# Design Review Board

April 10, 2019

5:40 - 6:40	7) <a href="#">Deep Pine Overlook PUD/SCUP</a>	Dean Gunderson
6:40 - 7:40	8) <a href="#">Riverfront Park-North Bank</a>	Dean Gunderson
7:40 - 8:40	9) <a href="#">PFD-SportsPlex</a>	Alex Mann

Exhibit F →  
Example landscaping

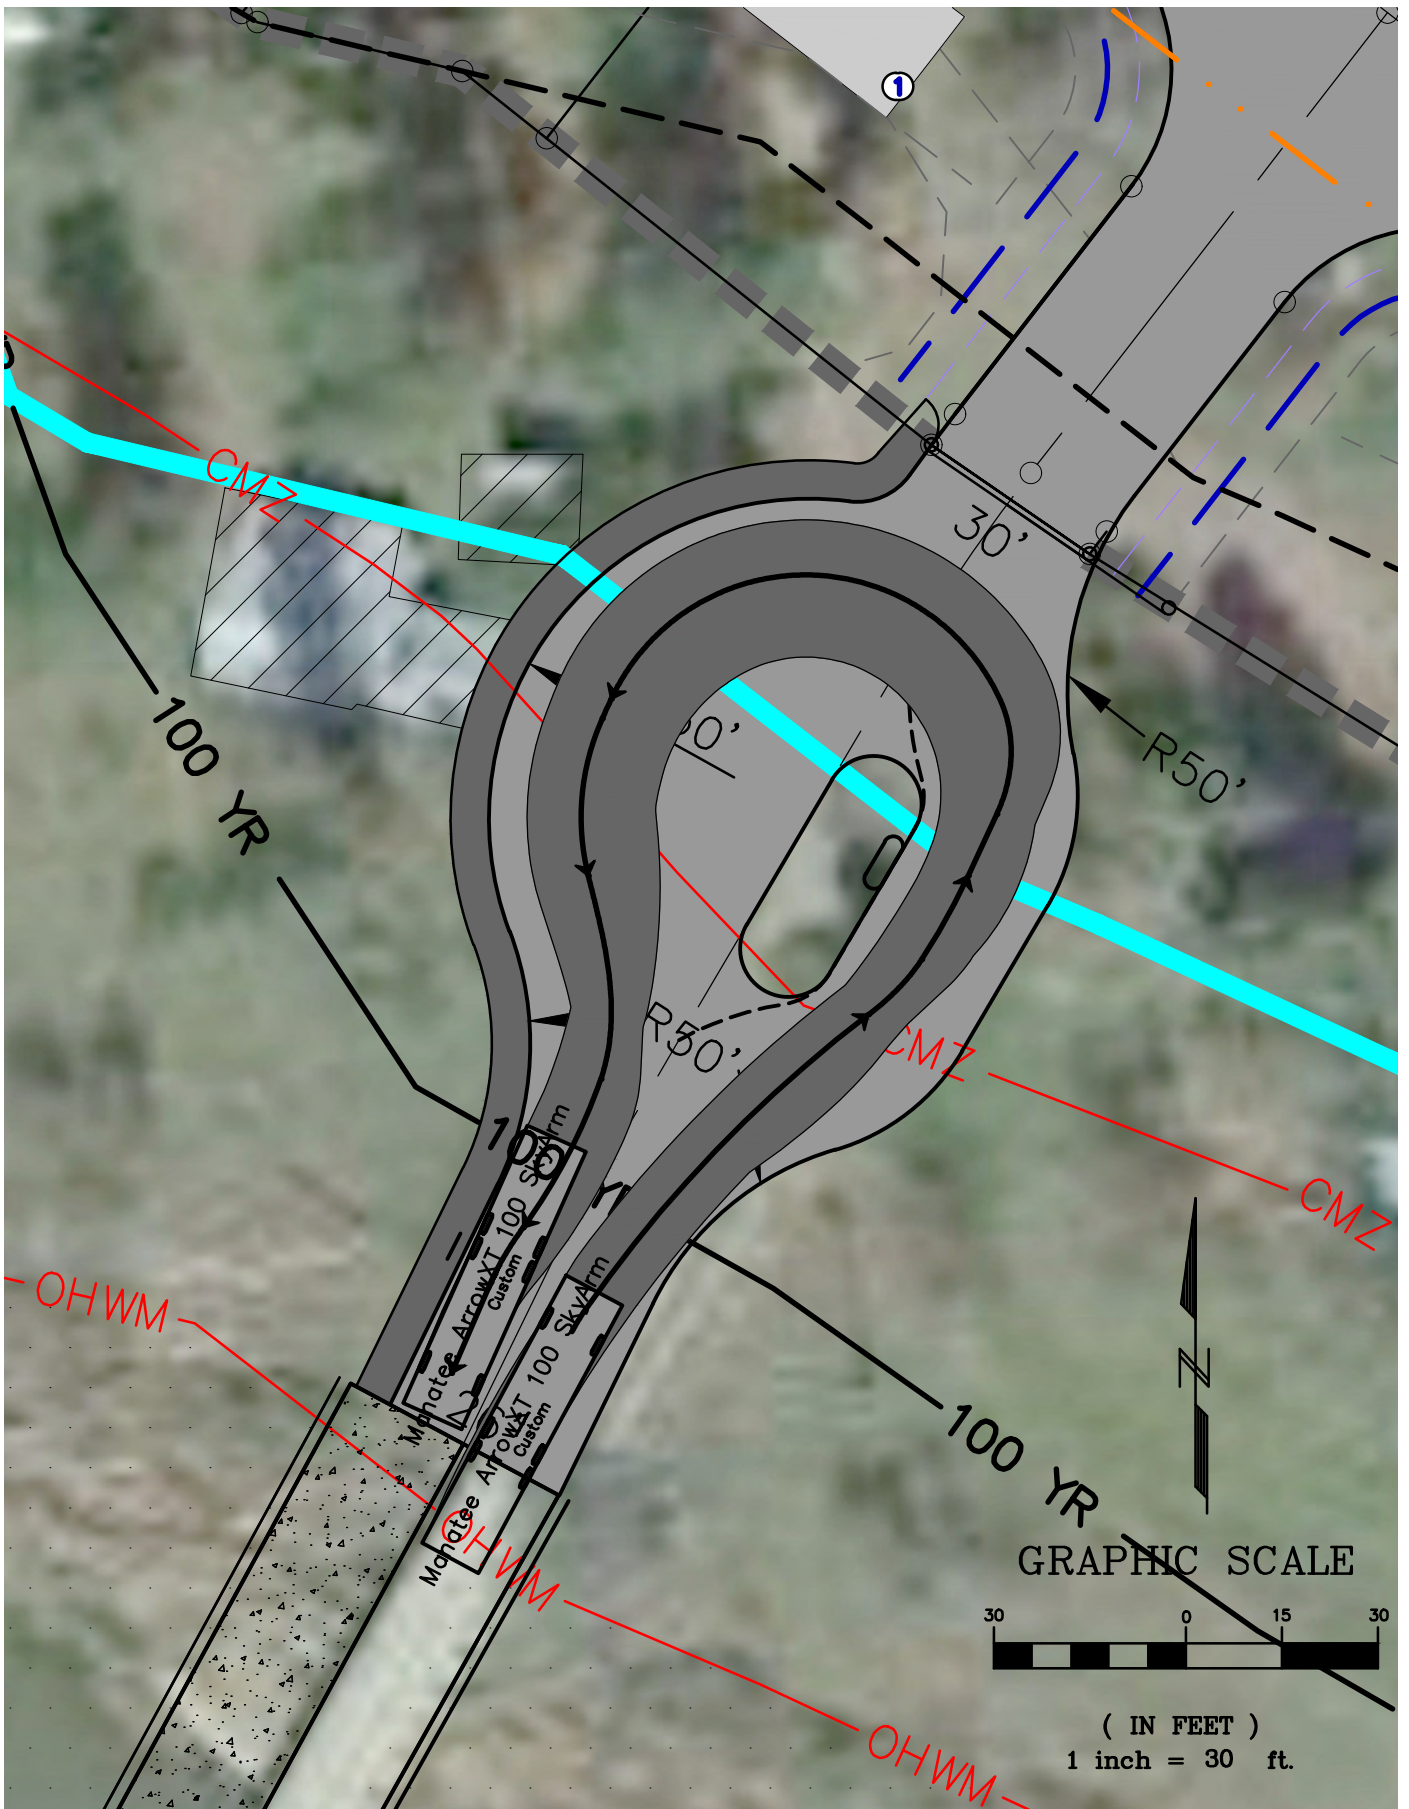
**1. The Applicant shall provide additional information on the proposed treatment of site fencing with attention paid to the site constraints and opportunities.**

We believe that a combination of what would be considered historical agricultural fencing and gating materials would lend themselves well to a community in this area of Spokane. This development plan would link modern development demanded by homeowners with the rich heritage of our community.

Applicant's preliminary design (example below) acknowledges the historical character of the area as well as the natural habitat within which the development is planned.

# NORTH/SOUTH PEDESTRIAN CONNECTION

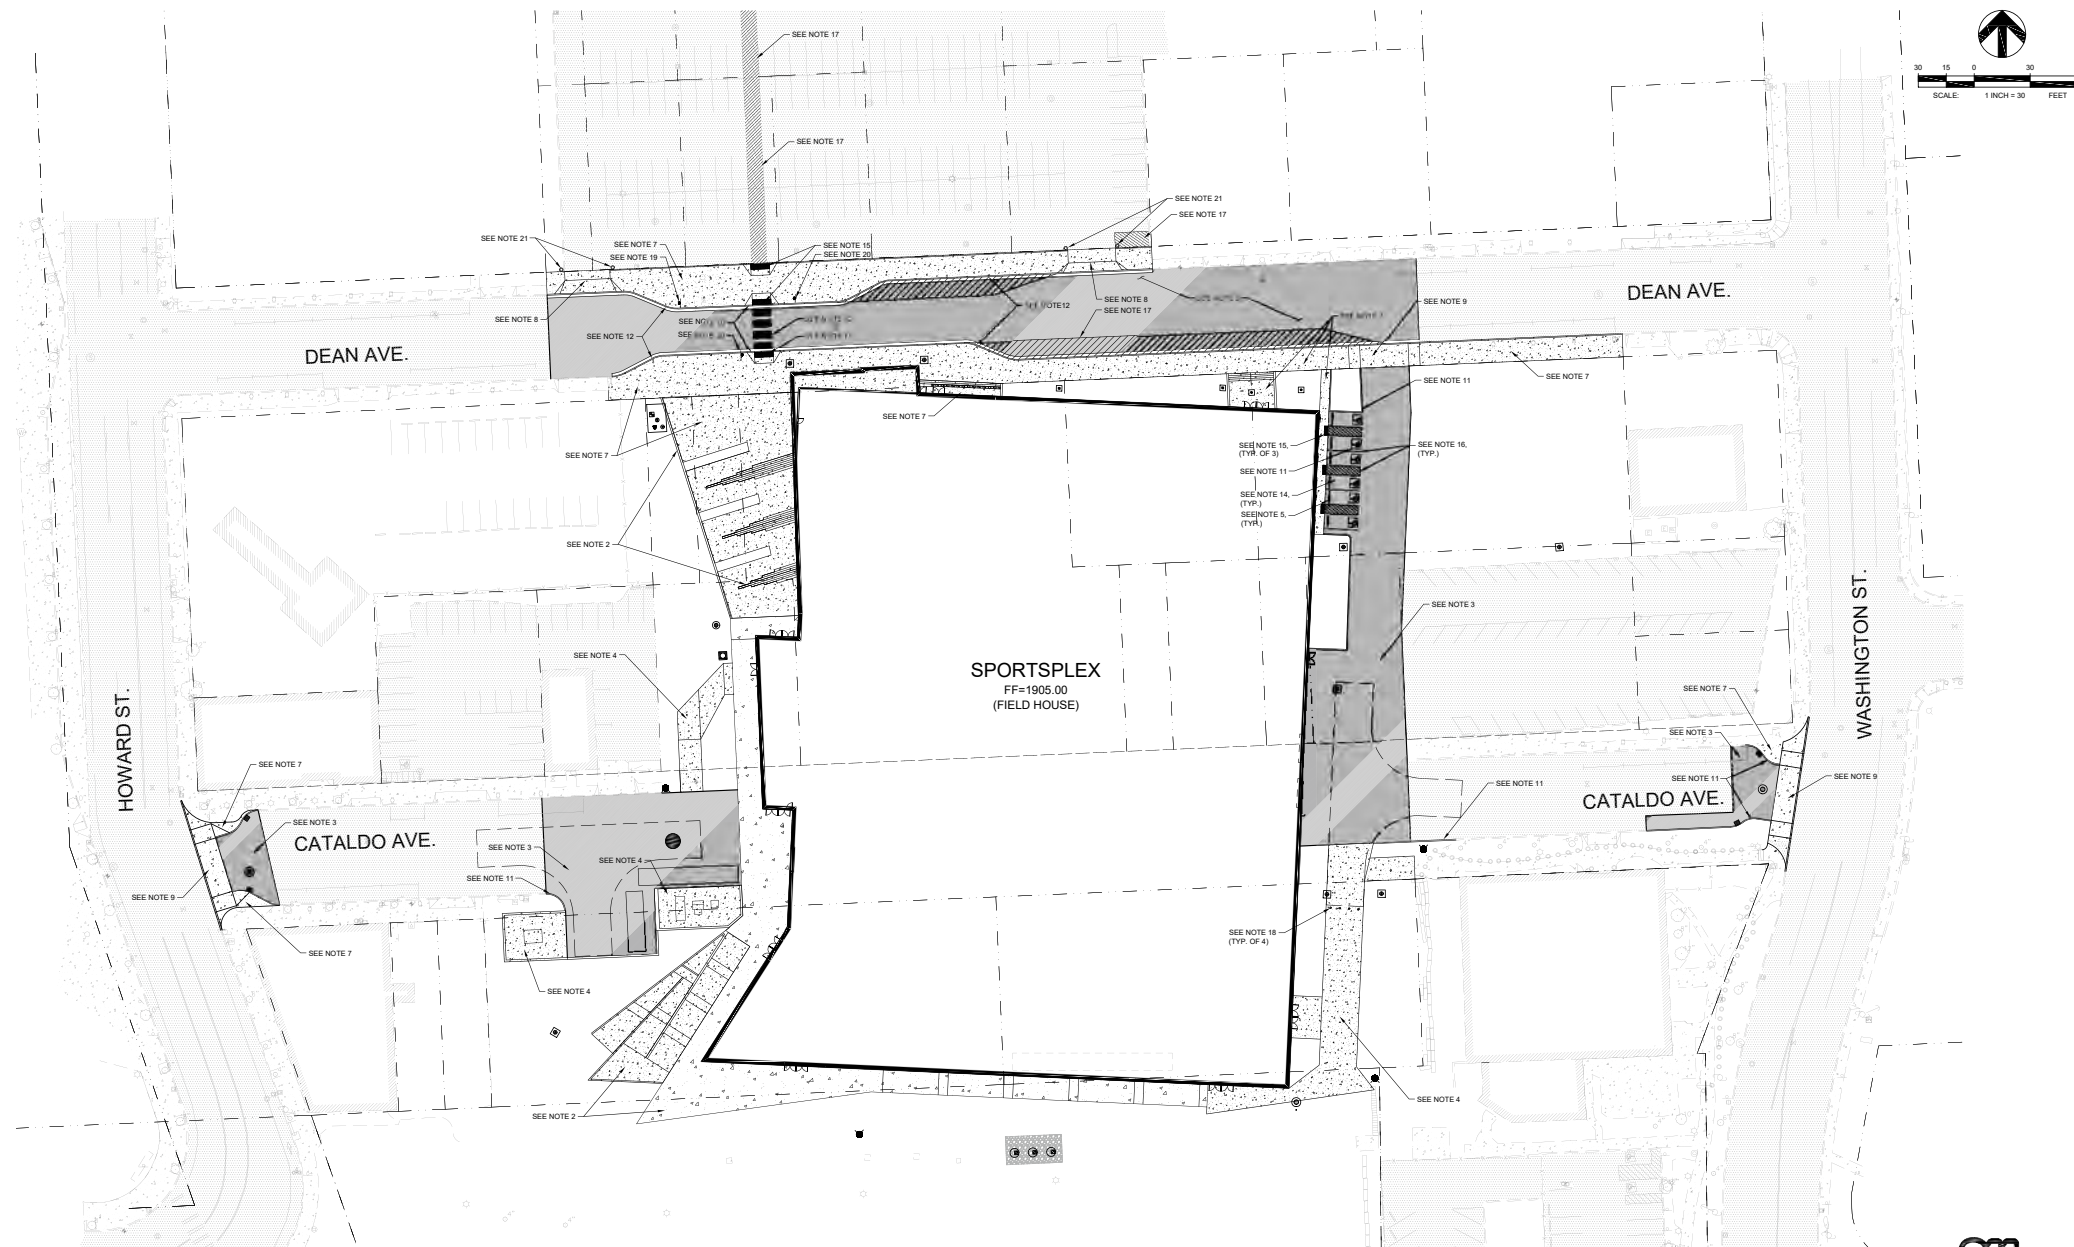
The applicant shall continue investigating stronger north-south pedestrian connections across Dean Avenue
